TRANSMITTAL COVER SHEET

DATE: 21 June, 2024
TO: ALL PLAN HOLDERS OF RECORD
FROM: HUNTER SWATEK, AIA, PROJECT MANAGER
PROJECT: RAINBOW CITY RECREATION CENTER
GMC PROJECT NO. ABHM230021
RE: ADDENDUM NO. 3 AND
ACKNOWLEDGEMENT OF RECEIPT OF ADDENDUM NO. 3

ADDENDUM NUMBER 03

**PROJECT: RAINBOW CITY RECREATION CENTER
GM&C PROJECT NO. ABHM230021**

POOL LAYOUT

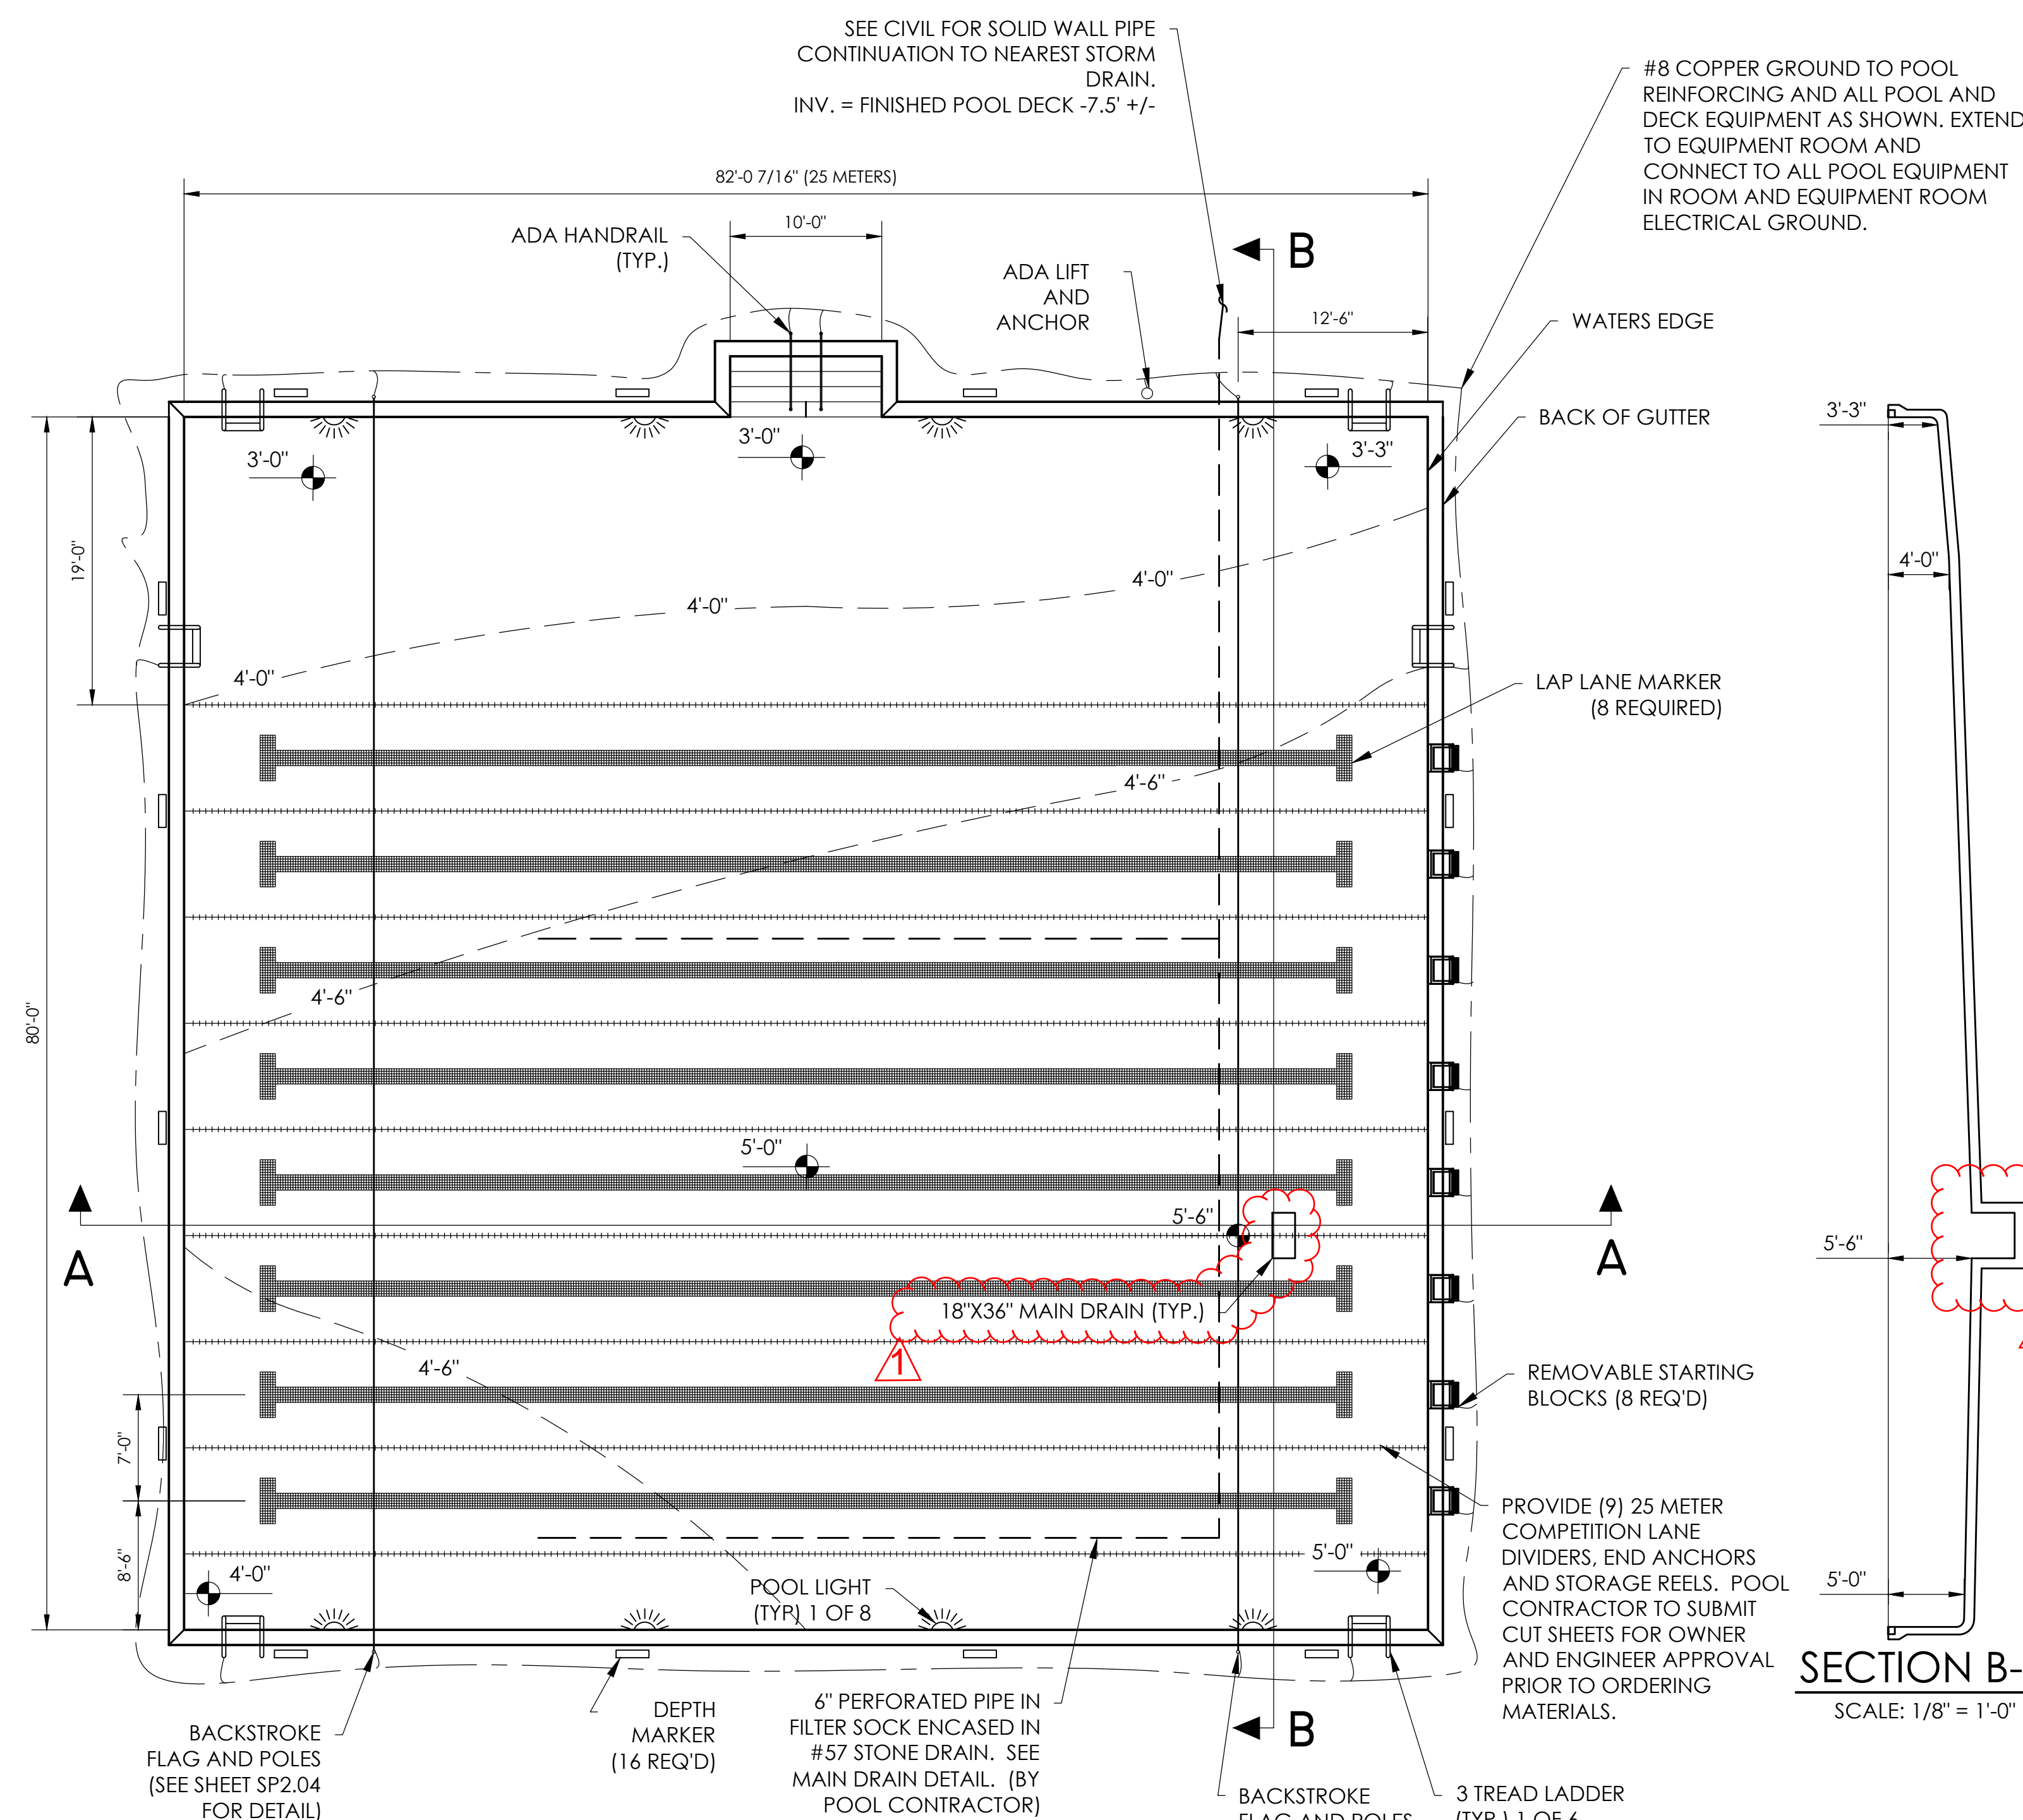
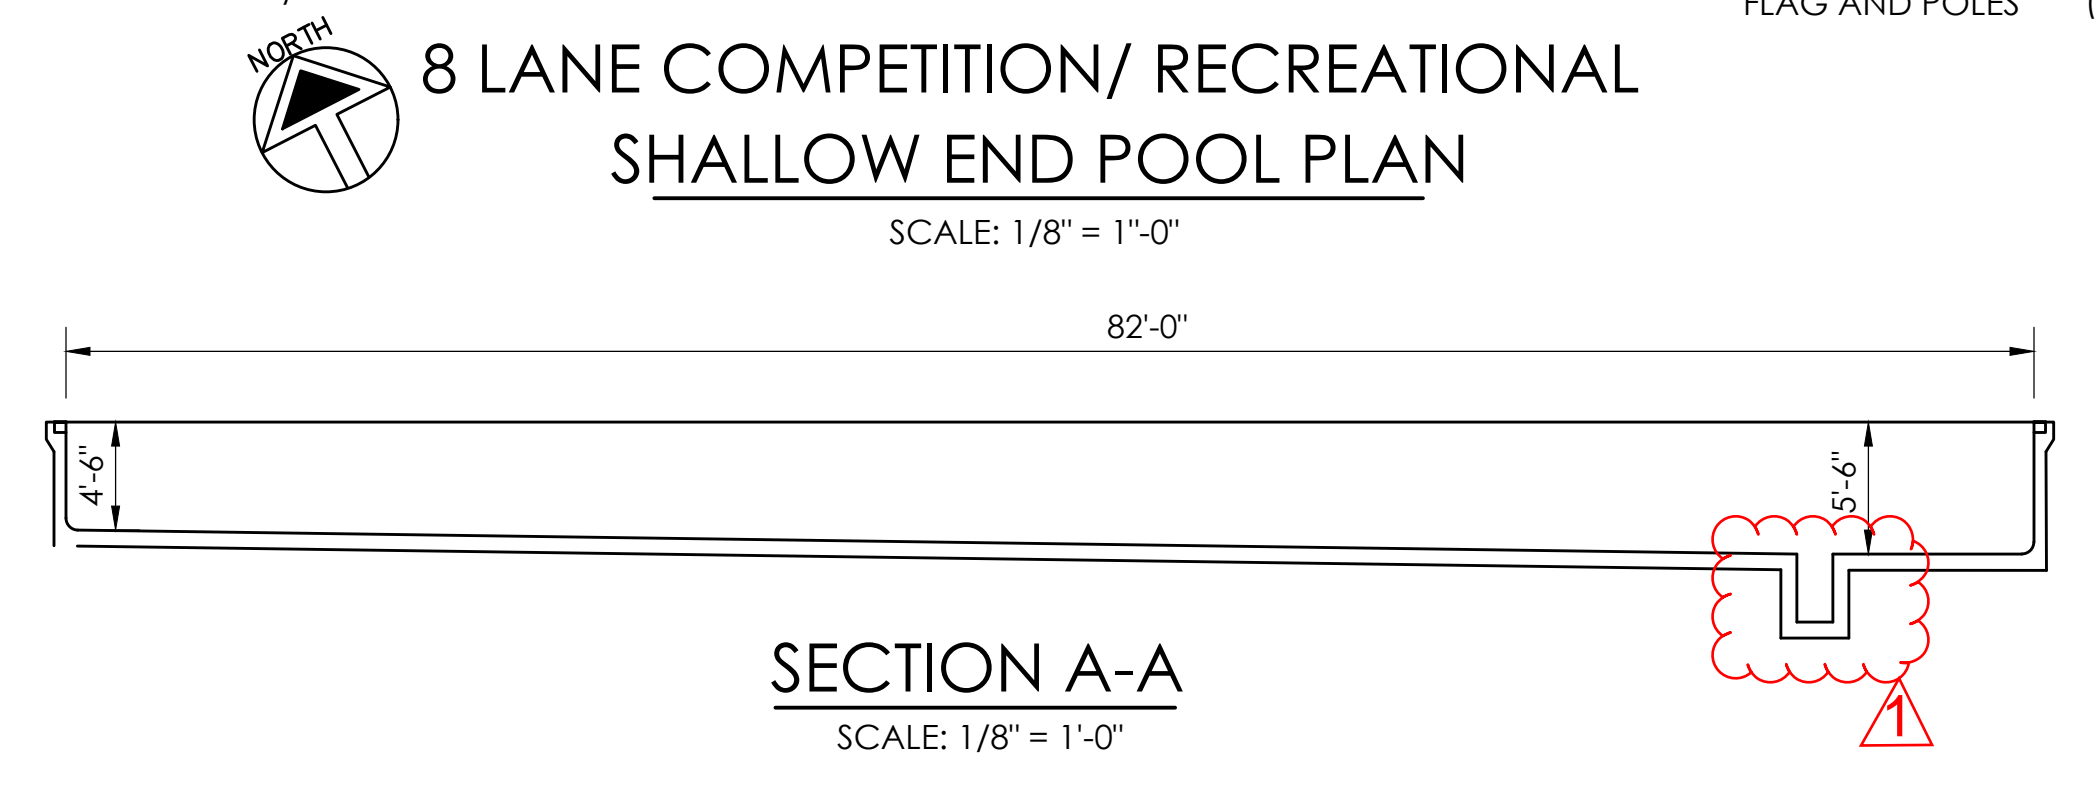
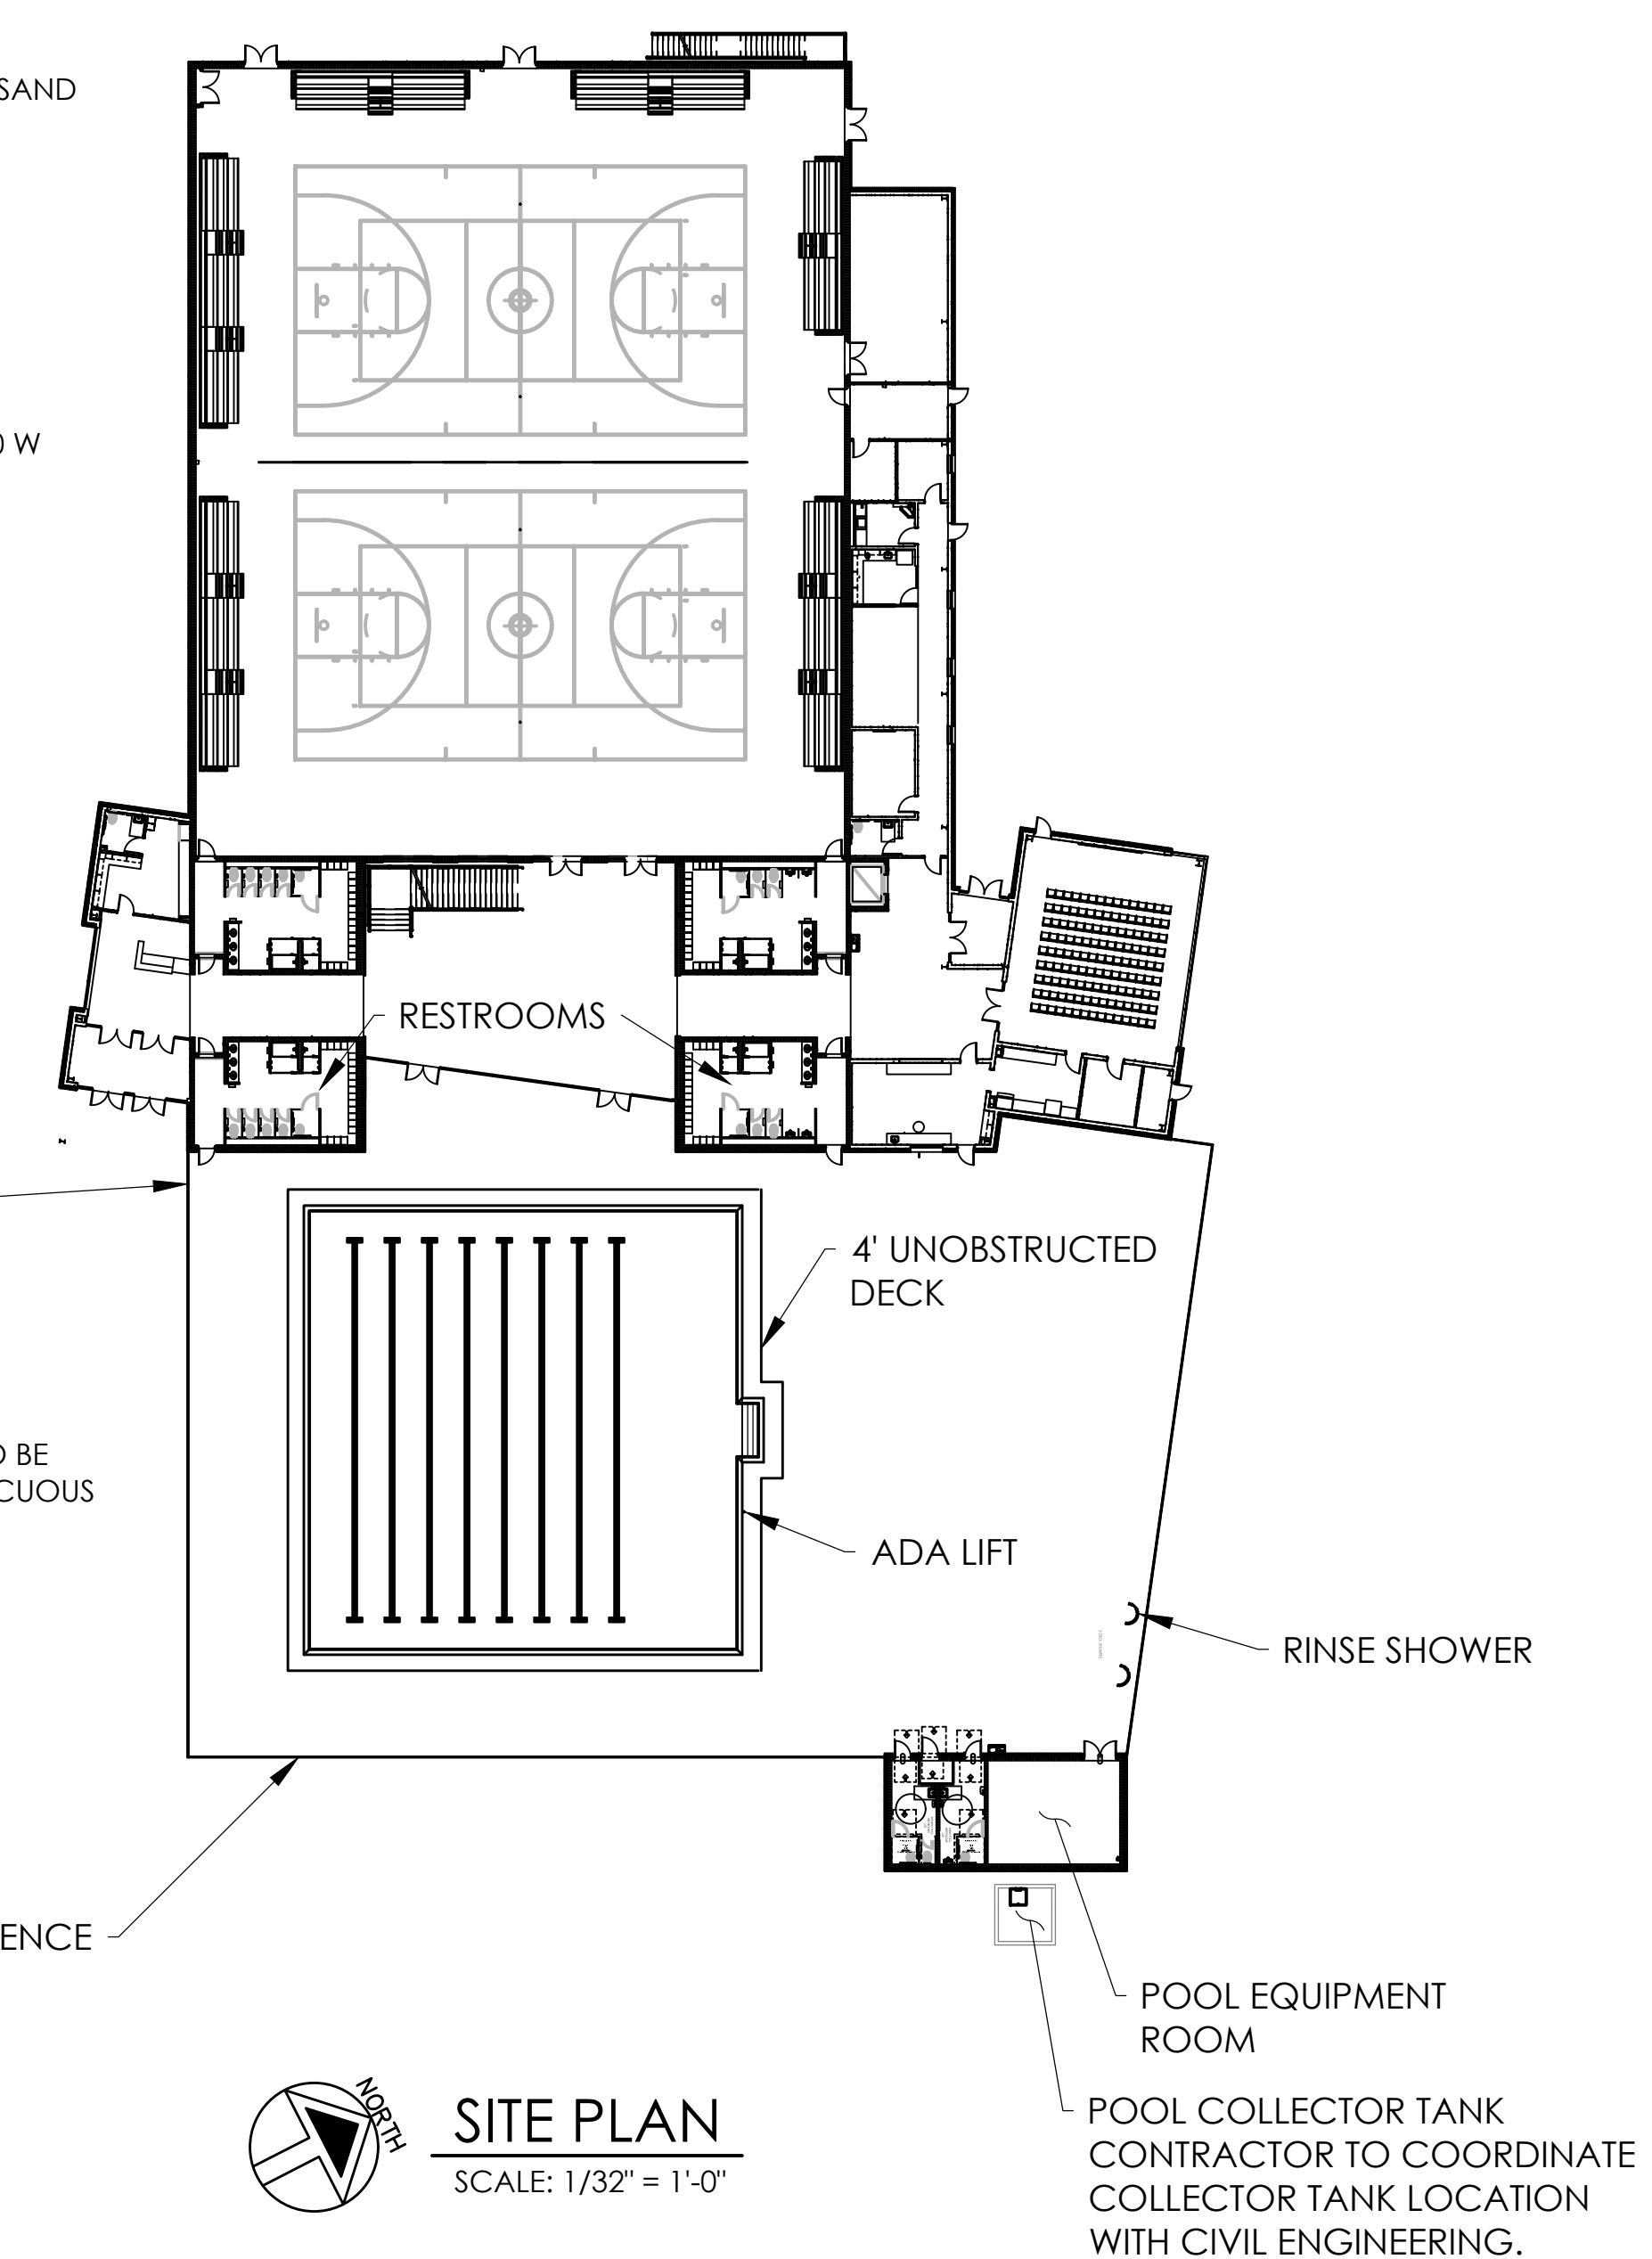
- b. REVISED Discharge pump tag
 - c. ADDED Pool filter sump along with 8" storm piping connecting to the 6" FS
- FF. SP1.01, SP1.02, SP2.01, SP2.02, SP2.03, SP2.04 – Pool Addendum 03**
- a. Pool main drains have been updated from (3) 24"x24" Drains to (1) 18"x36" Drain.
 - b. Note added on Pool reinforcement.
 - c. Note added regarding gutter warranty requirement.
 - d. Note added regarding alternate vendors requirement.
 - e. Specifications sheets have been provided for pool.

The pool designer called out the rebar spacing for the wall but not the floor. See SP1.01, wall detail. Is the floor rebar also 9" OC or different? It appears to be different, please advise	3	See updated Pool Drawings
	Specification Section 12 6613, Part 2.02 A requires seating to be manually operated. However, Part 2.02, B 6 requires electrically operated. Please clarify.	3	All telescoping bleachers to be manually operated.
	Porter is specified for the Gymnasium Equipment. However, they are not specified for Section 116653-Gymnasium Dividers. Do they need to submit a Substitution Request to be allowed to bid the Gymnasium Dividers? Usually Gymnasium Equipment and Dividers are supplied by the same vendor.	3	Porter is approved for both gymnasium equipment and dividers.
	The specifications are calling for the metals to be a 3-coat finish. The supplier just reached out and said that we could not get a quote on this due to the size, we would not meet the minimum order quantity for special finishes. Please advise if we should quote the standard 2-coat finish.	3	The metal panels in 07 4291 can be finished in a 2-coat Fluoropolymer (Kynar) finish
